# Technical Service Bulletin

## 00 - Engine shuts off and/or EPB activates when driver door is opened

00 13 46 2031850/3 March 13, 2013. Supersedes Technical Service Bulletin Group 00 number 13-44 dated January 17, 2013 for reasons listed below.

Model(s)	Year	VIN Range	Vehicle-Specific Equipment
A6/A7	2013	All	Not Applicable
A8	2013	All	Start-Stop
Q5	2013

**Figure 1.** Old Start-Stop glovebox insert.

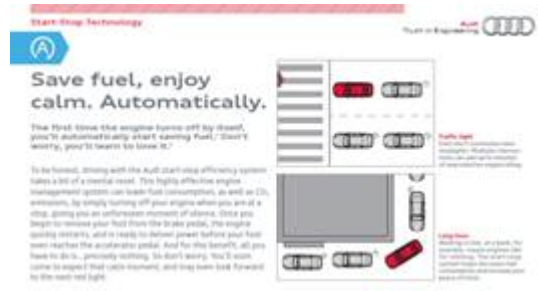
4. If available, replace the old Start-Stop glovebox insert (Figure 1), with the new glovebox insert **BR-12-631-US** (Figure 2). Additional inserts may be ordered from the Brand Store.

**Figure 2.** New Start-Stop glovebox insert.
